SUBJECT: RFP #PW23-3, Health, Dining and Housing Building Project, Project PLY106

## Addendum #1

**STORM DRAIN PLAN, DETAILS, AND SPEC SHEETS**

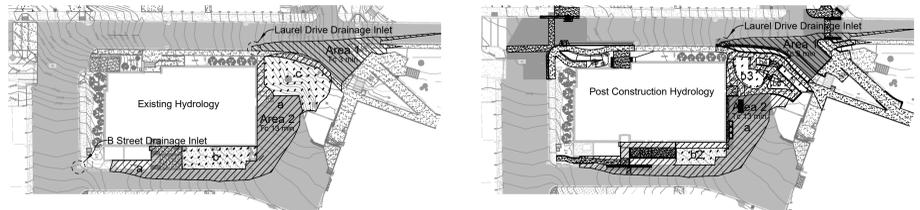
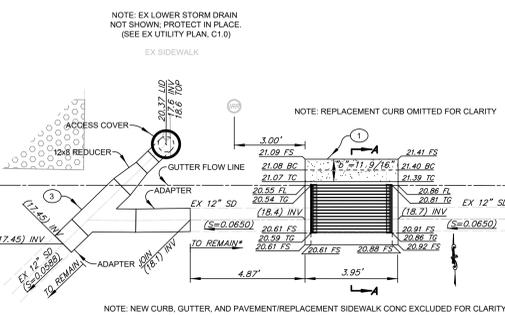
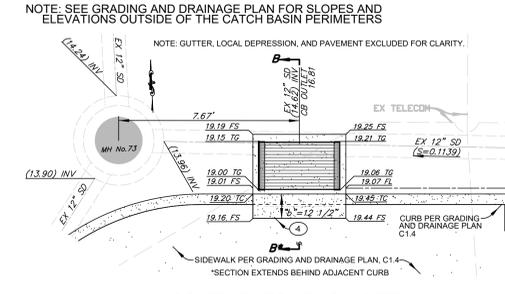
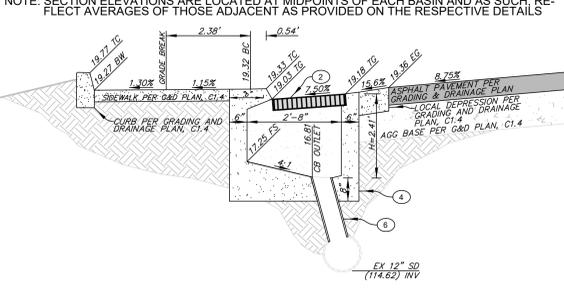
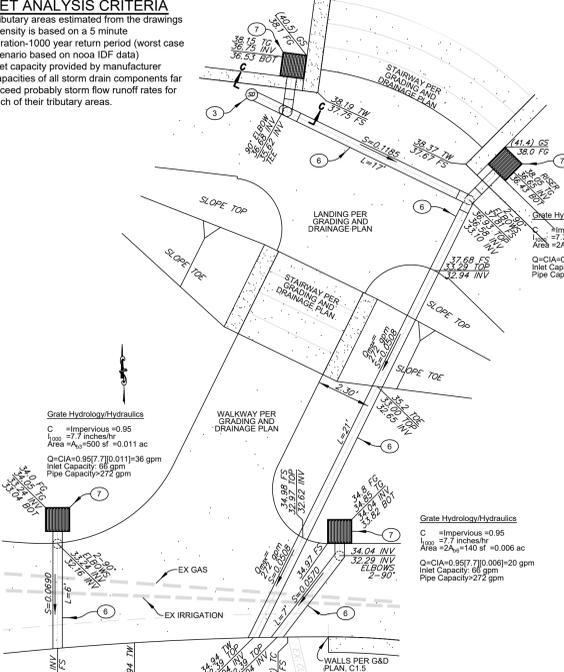
Q3. Additionally, what are the site boundaries for the Jenkins Hall scope? Should we consider any upgrades to the immediate site to meet campus master plan guidelines such as ADA access, stormwater management etc.?

**Answer: Site boundaries are anticipated to be similar to that shown in Exhibit P.1 Jenkins Hall Plan Excerpts. See also Sheet C1.1 attached.**
